FIRE SAFETY INSPECTION REPORT

CRONY TEX SWEATER LTD.

**PLOT NO. 190-193, 206-209, BLOCK B, BSCIC
INDUSTRIAL ESTATE, FATULLAH**

May 10, 2014

F-10 Egress

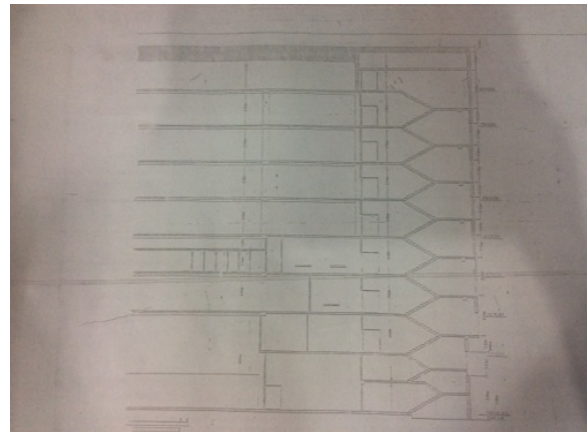
The south exit stairs discharge inside the building in an entry vestibule area which is open to store rooms and contains combustible storage.

Provide 2-hr fire-rated exit passageway leading directly outside (vestibules to separate any storage areas).

Provide sprinkler protection for discharge floor in accordance with NFPA 13.

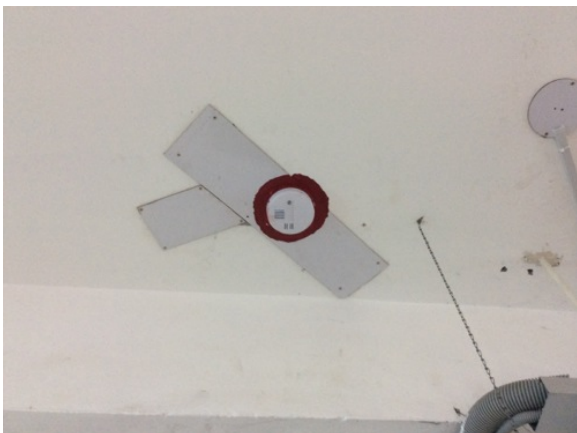
F-14	Fire Protection	The building is equipped with single-station smoke alarms. Smoke alarm activation sounds only a local alarm and does not provide automatic fire alarm notification of occupants.	Remove single-station smoke alarms. Provide automatic smoke detection throughout the building in accordance with NFPA 72.	Within 6 months
------	-----------------	--	---	-----------------
